**DATE:** 07.10.2018  
**TO:** ProTrak  
**FROM:** Mitesh Baxi  
Traffic Engineering

■ **SOCIAL COFFEE AND SUPPLY COMPANY [TRC Plan Review]**

↻ Initial Review Note ↻

**NCDOT:**

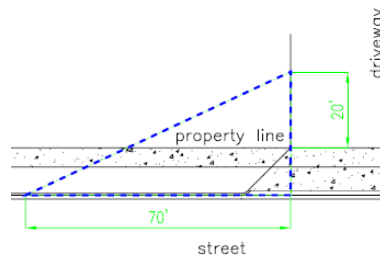
It is the Applicant’s responsibility to coordinate directly with NCDOT to determine if any driveway permits/ revisions/ review processes are required. Contact NCDOT at 910. 251.2655. Please note additional comments may be forthcoming once coordination occurs.
